► Change on motor housing, rear cover, etc.

► 9218PB, 9218PBL (Polisher), 9218SB, 9215SB (Disc Sander)

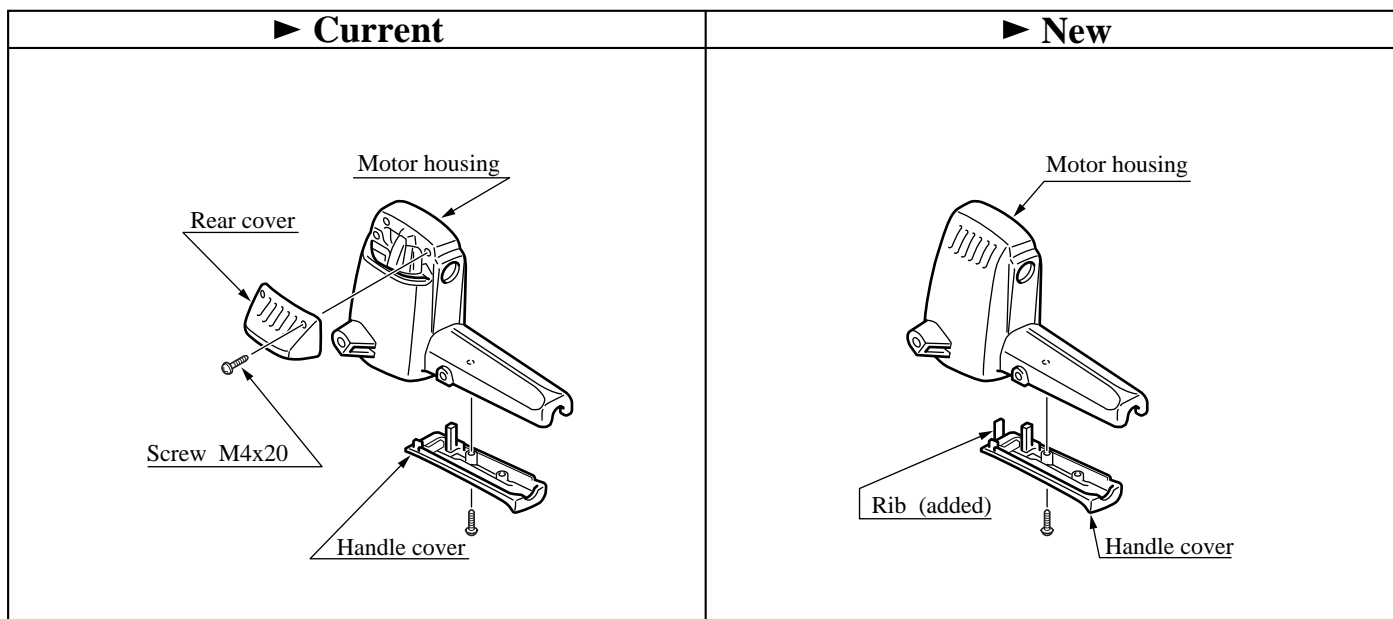
- 1. The rear cover will be molded into the motor housing. Consequently, the screw M4x20 will be discontinued.
- 2. The hole in the motor housing, through which the field lead wires run, will be changed to a square groove.
- 3. A rib will be added to the handle cover as shown in the figure below.

The new type handle cover can fit into the current type motor housing if you remove the rib from the new type handle cover.
